**WATER QUALITY**  
**MEMORANDUM**  
Utah Coal Regulatory Program

TO: Internal File  
THRU: Daron Haddock, Permit Supervisor *DQH*  
FROM: James D. Smith, Environmental Scientist III *JDS 01 Sept 2010*  
RE: 2010 First Quarter Water Monitoring, Canyon Fuel Company, LLC,  
Skyline Mine, C/007/0005, Task ID #3482

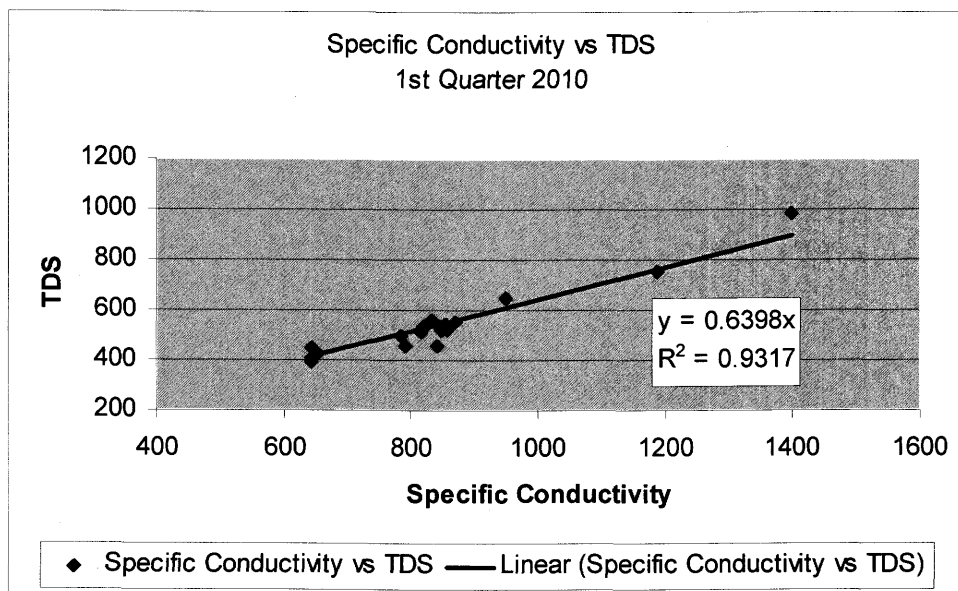
- TDS/Conductivity
  - Out of 21 samples for which both field specific conductivity and TDS were determined, 20 have a TDS/Conductivity ratio in the expected range between 0.55 and 0.76. The 21<sup>st</sup> sample, VC-6, is just outside that range, at 0.54.
    - The linear trendline has a slope of 0.64 (see chart).
    - UPDES discharges account for 15 of the 21 samples.
